## ENGAGEMENT SUMMARY

# SPRINGBANK PARK ESTATES + ROYAL SPRING ESTATES

Date: February 1, 2021

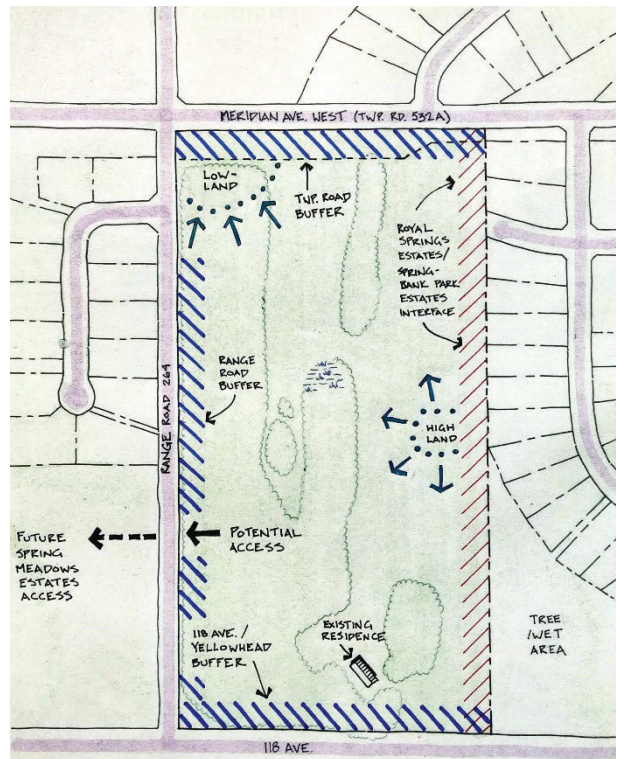
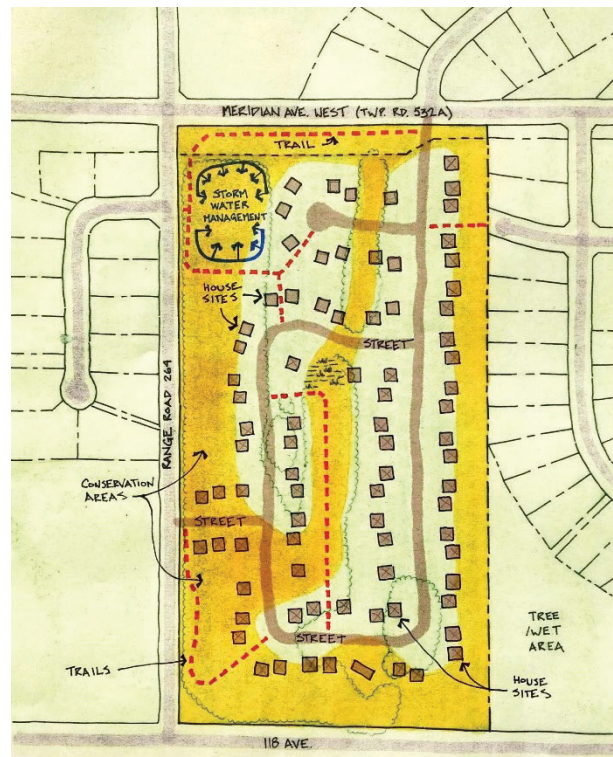
The only question I have is regarding the existing wet land in the middle of the site and how is it going to drain?

The proposed road and residential lots are going to obstruct the natural surface drainage pattern. I am assuming a culvert would be installed at the road so drainage can flow under the road, but then for the surface drainage to get to the constructed wetland, it would have to flow through the residential lots or follow road ditches the long way around and against the existing topography.

Utilizing the existing topography and LID approach, the concept could consider a long linear wetland drainage feature (rain garden, bioswale), connecting the existing wetland to the low part of the site, instead of the typical large constructed wetland.

I wonder if future residents would prefer a larger and longer noise attenuation berm along the highway? The negative would be the need to remove much of the existing vegetation screen along the south end of the project site.

Further assessment of the existing tree stand for age and health should be undertaken so the design and client team can weigh the pros and cons of the existing tree removal in place of a vegetated noise attenuation berm.
